**ISSUE:** Concept of four condominium buildings

**APPLICANT:** Robert S. Brandt, Inc.

**LOCATION:** 900 N. Washington St

**ZONE:** OCM

**Figure 1** Current proposed site plan

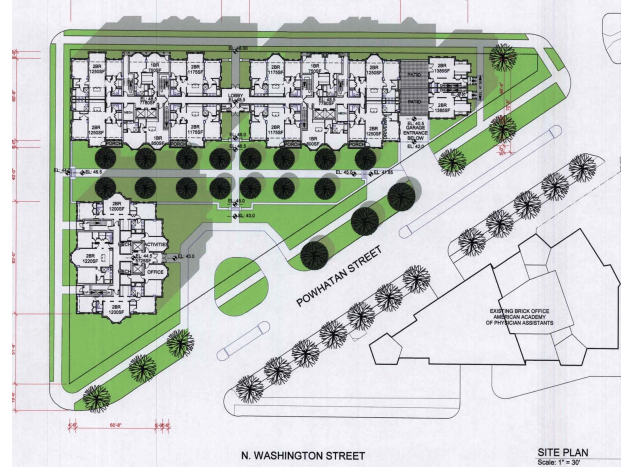
The National Park Service also commented that site elements such as landscaping and elimination of the vehicle turn-around on Powhatan Street need to be addressed. These site elements will be reviewed by the Planning Commission.

**Figure 3** - Proposed Montgomery Street (South) elevation

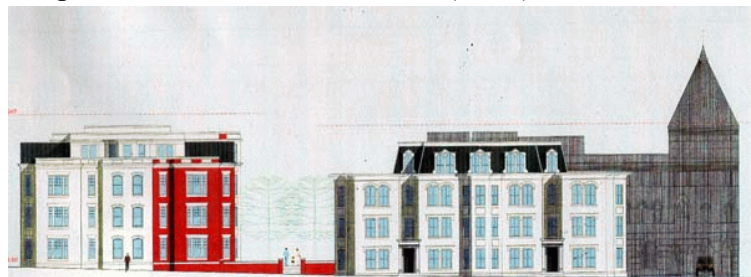
While there have been several positive changes to the proposal, the numerous revisions have also resulted in areas which require additional refinement. The variations in the roof heights and the depth of the building setbacks in the original proposal were reduced in the redesigned project. As a result, staff is recommending the following revisions to comply with the Washington Street Standards:

- the fourth floor be made substantially less visible and prominent by providing increased setbacks, or through the use of colors and/or roof forms;
- provision of a functional entrance on the Washington Street building; and
- additional variety of materials, windows and colors to comply with the Washington Street Standards.

Figure 11 - Building height study  
March 1<sup>st</sup> BAR hearing

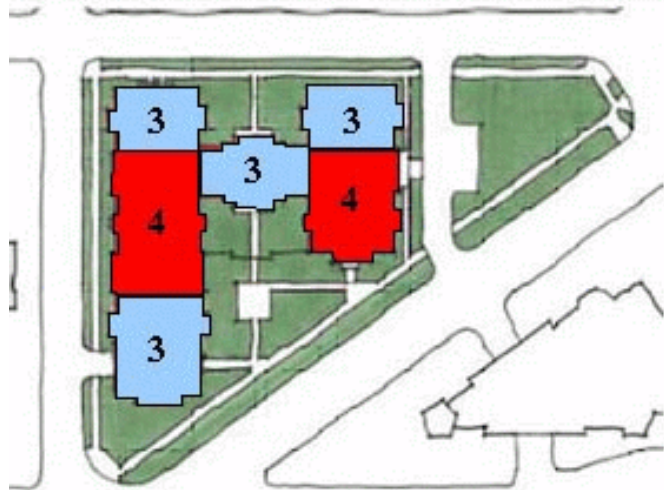
This concept was presented to the BAR, and deferred, with comments that it displayed:

- inappropriate scale and mass on Washington and Montgomery Streets
- a “collage of styles” inappropriate for Old Town
- three buildings all competing for attention: applicant was told to revise the buildings to be more background-type buildings, that do not compete with the buildings on Washington Street.

Figure 12 - Building height study

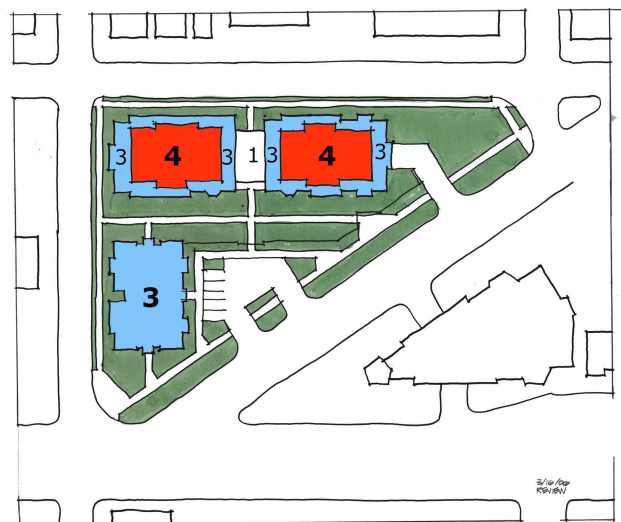
Staff discussed the possibility of retaining the original site plan while also addressing the comments from the Board. However, based on the BAR deferral and comments, the applicant redesigned the site plan. The proposal was revised to consist of three simple flat-roofed apartment blocks, the two along Columbus Street four stories in height, and the building on Washington Street three stories, with building breaks mid-block on both Montgomery and Columbus Streets. A one-story shared lobby/entrance was shown between the two

**Figure 14 - Building height study**  
May 3<sup>rd</sup> BAR hearing

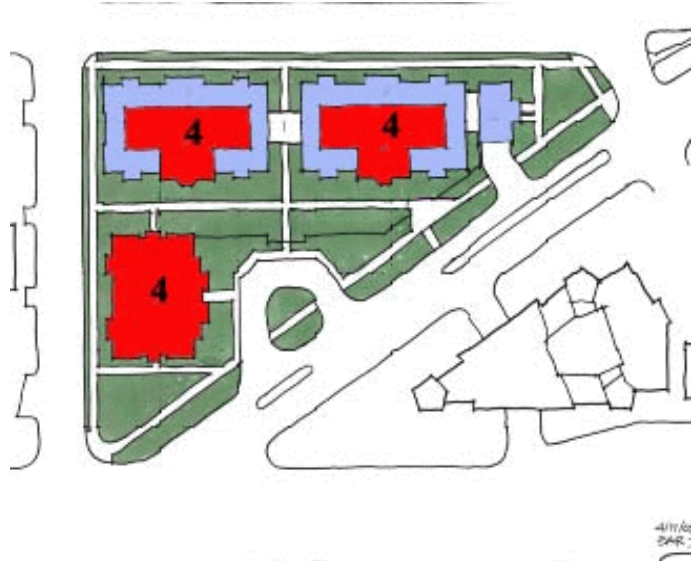
Staff continued to encourage incorporation of elements from the original proposal; however, staff did not oppose the general direction of the revised proposal but staff recommended additional design and refinement to deal with issues of mass and scale on Washington Street and the problems raised by the fourth floor on Columbus Street, to bring the project into compliance with the Washington Street Standards. There was public opposition expressed, and the Board voted to defer to address issues of mass, scale and architectural compatibility.
